SUNDRY NOTICES AND REPORTS ON WELLS
Do not use this form for proposals to drill or to re-enter an abandoned well. Use form 3160-3 (APD) for such proposals.

8. Well Name and No.
JUNIPER COM 21 14

Final P&A Procedure Basin Fruitland Coal Formation

CONDITIONS OF APPROVAL

**COLEMAN OIL GAS, INC.
JUNIPER COM 21#14**

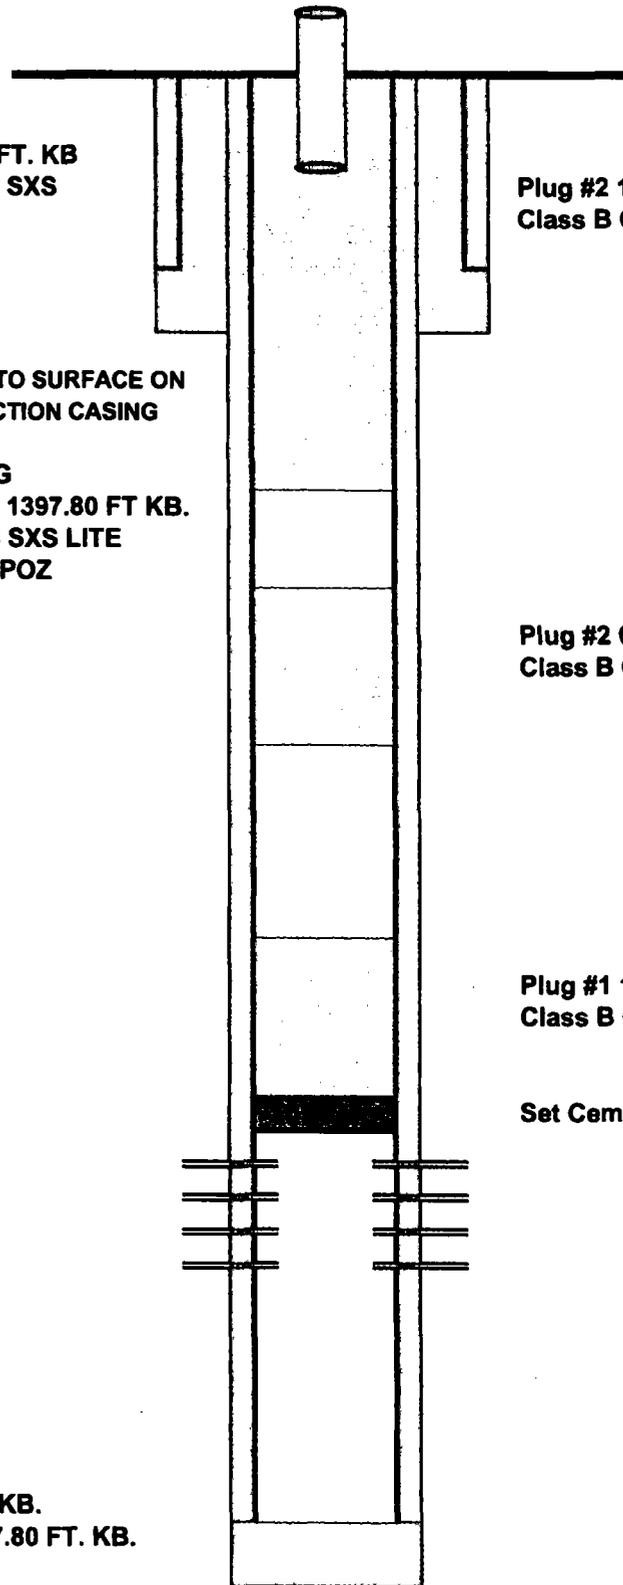
1. Plugging operations authorized are subject to the attached "General Requirements for Permanent Abandonment of Wells on Federal and Indian Lease."
2. Farmington Office is to be notified at least 24 hours before the plugging operations commence (505) 564-7750.
 - a) Set Plug #1 (1182'-981') ft. To cover the top of Fruitland top. BLM picks top of Fruitland at 1031 ft.

**Plug #1 1182' - 1025'
Class B Cement 24 sacks**
